SERVICE BULLETIN

BULLETIN # 01-04
DATE: 1/04/2004
SUBJECT: 48 CONVERTIBLE
FUEL GAUGE
HULL #s: #37 to #

24V RESISTOR BOARD

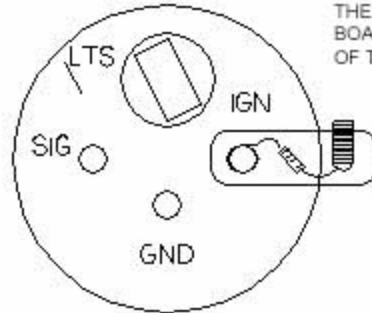
It has recently come to our attention the fuel gauge on your boat maybe missing the resister on the ignition feed that steps down the voltage to the gauge. Therefore Silverton will replace the fuel gauge due to possible damage from improper voltage. Below is the photo showing the resister. The below instructions describe how to install the fuel gauge. Estimated time to complete this installation is 30 minutes.

PLACE RESISTOR BOARD ONTO THE
IGN POST ON THE BACK OF GAUGE.
THE POST ON THE RESISTOR
BOARD WILL THEN BE USED IN PLACE
OF THE IGN POST ON THE GAUGE
